# Safety Notice

# SN-614-14

SUBJECT: Platform rotate cylinder

Location at boom tip behind cover

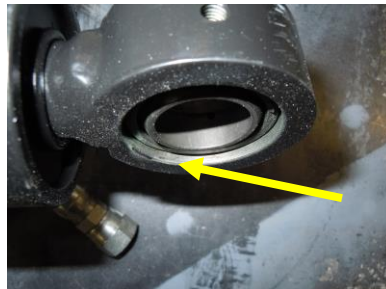
1. Immediately inspect the platform rotation cylinder ball bushings at the boom tip on all affected machines. Verify that the ball bushing outer race is centered in the cylinder rod and base ends. The base end will be flush and the rod end will be recessed .13 inch on each side as shown in the pictures below.

Base end - bearing outer race flush

Rod end - recessed .13 inch each side

2. If the ball bushing is not centered in the cylinder rod or base ends, or the ball bushing is loose in either the cylinder rod or base ends and has moved so that the ball bushing are not in the positions shown above do not operate the unit, take it out of service immediately. Contact your local Terex dealer or TEREX Utilities at 605-882-4000 or email machine information to [utilities.warranty@terex.com](mailto:utilities.warranty@terex.com) to arrange repair before further use.
3. Destroy the affected cylinder once the new cylinder has been installed.
